CONSERVATION COMMISSION AGENDA

Date: January 30, 2020

- 2. 148 Pine Street NOI demo of existing duplex and construction of 3 single-family homes DEP File #239-856
 - Owner/Applicant: Vincent Mastroianni, 148 Pine Realty Trust Representative: John Rockwood, EcoTec, Inc.

2) 48 PINE ST. EXISTING CONDITIONS/SITE PREF

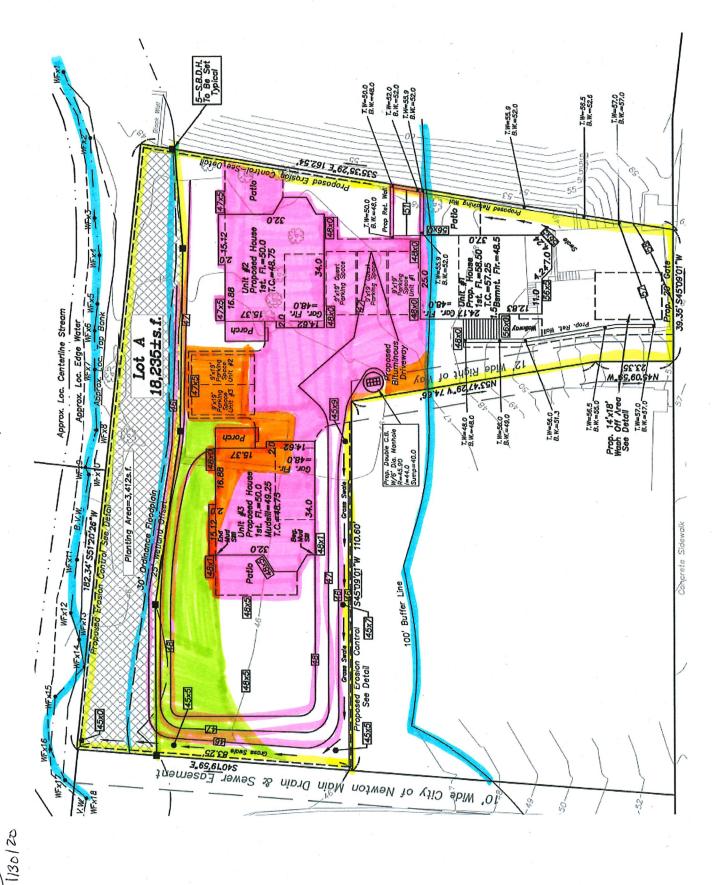
- <u>Engineering comment</u>: Due to the fact that the entire paved surface area is being collected into one double catch basin and being directed to an on-site subsurface collection system, it is recommended that an advanced stormwater treatment unit (STU) be installed prior to discharge. The treatment unit would replace the proposed drainage manhole which receives flow from the double catch basin. The Operations and Maintenance plan would need to be updated to include the STU.

- The revised the erosion control line runs through existing vegetation (to be removed) and the existing garage and
 driveway (both to be removed). Erosion control locations should be revised to make sense with the necessary site
 demo, as the erosion controls will need to be installed prior to a pre-construction site visit and any work on site. If
 the secondary compost sock is not to be installed until after site demo, this should be clarified on the plans.

- Applicant should show snow storage areas on the plan to clarify that no snow will be pushed or stored from the parking area between unit 2 and unit 3 into the mitigation planting area.

- Applicant should clarify why there are 2 sharp angles in the proposed 47' elevation. It does not seem to be designed in a logical way.
- Test pit #3 logs indicate standing water at 2 feet below existing grade (44' elevation) but gave no indications of where mottling begins. Staff have concerns that seasonal high groundwater may be higher than the standing water seen during the August test pits and that the required 2 feet of separation for the infiltration system will not be met. This concern was not able to be discussed with Engineering prior to the publishing of this agenda.

- The secondary compost sock proposed to demarcate the mitigation planting area should be placed immediately after site demo and remain in place as a visual barrier to construction efforts that equipment shall not enter.

- <u>Prohibition</u>: Grading along the property boundary between 148 and 146 Pine Street shall not impede the flow of surface runoff from 146 Pine St to Brunnen Brook.

- <u>Perpetual Prohibition</u>: Snow may not be pushed or stored within the bounded mitigation planting area.
 - <u>Perpetual</u>: No further development on Unit 2 and Unit 3 closer to Brunnen Brook will be allowed, including decks, patios, or hot tubs.
